**STAFF REPORT**  
**COMMUNITY DEVELOPMENT DEPARTMENT**

HEARING DATE: April 15, 2021  
 TO: Planning & Zoning Commission  
 FROM: Sonya Allen, Associate Planner  
 208-884-5533  
 SUBJECT: H-2021-0014  
 Artemisia Subdivision – AZ, PP  
 LOCATION: 1690 W. Overland Rd., in the SE ¼ of  
 Section 14, T.3N., R.1W. (Parcel  
 #S1214449107)

Annexation and zoning (AZ) of 25.67-acres of land with a C-G (General Retail and Service Commercial) zoning district; and, Preliminary Plat (PP) consisting of 9 commercial buildable lots on 19.26-acres of land in the proposed C-G (General Retail and Service Commercial) zoning district.

**LANDSCAPE PLAN**  
**Kendall Site**

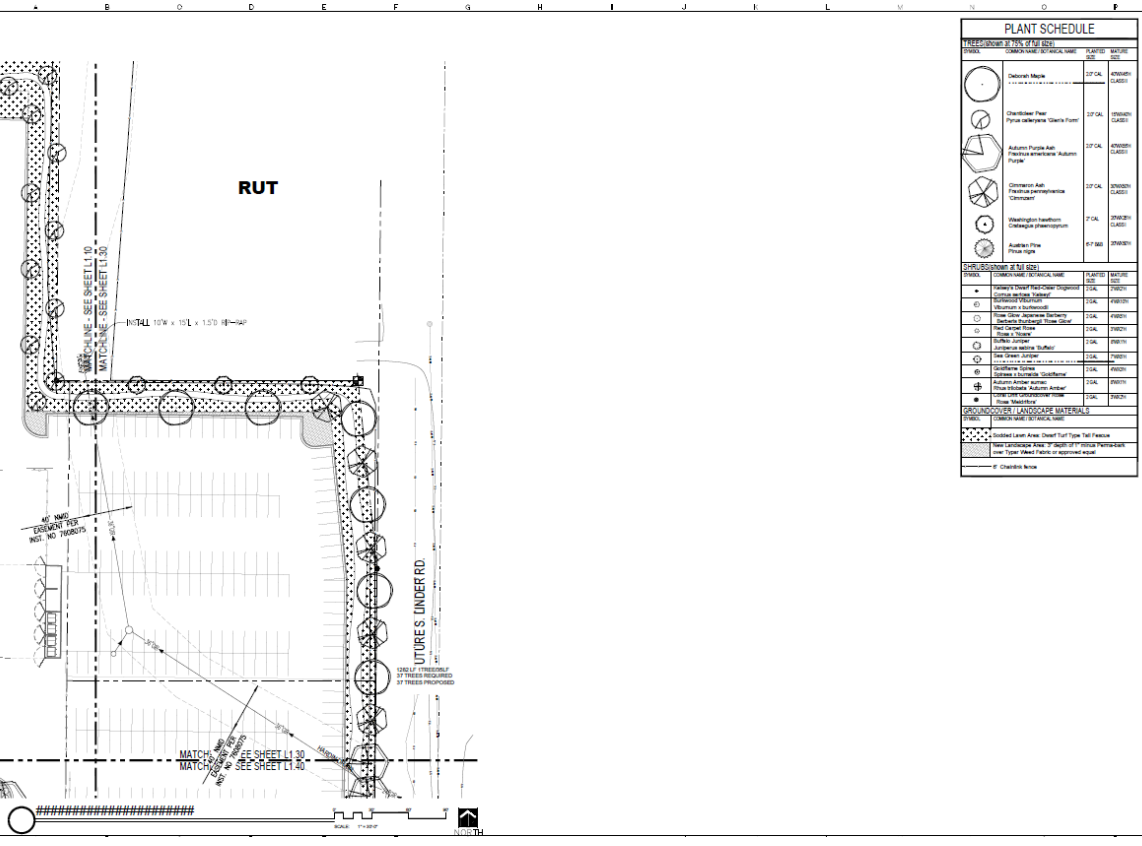
*The landscape plan depicts a pedestrian walkway within the landscape buffers around the perimeter of the development and sidewalks along internal public streets. **Additional internal pedestrian walkways should be provided between buildings within the site for pedestrian connectivity and from the perimeter sidewalks along Overland and Linder Roads to the main building entrances.***

All fencing is required to comply with the standards listed in UDC 11-3A-7. A 6-foot tall chain-link fence exists around the ITD storm drainage facility which is proposed to remain. **No fencing is depicted on the plan around the Kendall Ford; Staff recommends if fencing is proposed for security that it be of a higher quality than chain-link (i.e. wrought iron) – the Applicant should clarify at the hearing if fencing will be proposed and if so, what type of fencing is proposed.**

- c. Minimum 5-foot wide pedestrian walkways shall be provided from the perimeter sidewalks along Overland and Linder Roads to the main building entrances in accord with UDC 11-3A-19B.4a.

- d. Internal pedestrian walkways shall be provided between buildings within the site for pedestrian connectivity. Internal walkways shall be distinguished from the vehicular driving surfaces through the use of pavers, colored or scored concrete, or bricks in accord with UDC 11-3A-19B.4b.

- g. Compliance with the specific use standards listed in UDC [11-4-3-38](#): Vehicle Sales or Rental and Service is required.
  - h. If fencing is proposed for security around the Kendall Ford site, it shall be of a higher quality than chain-link (i.e. wrought iron).
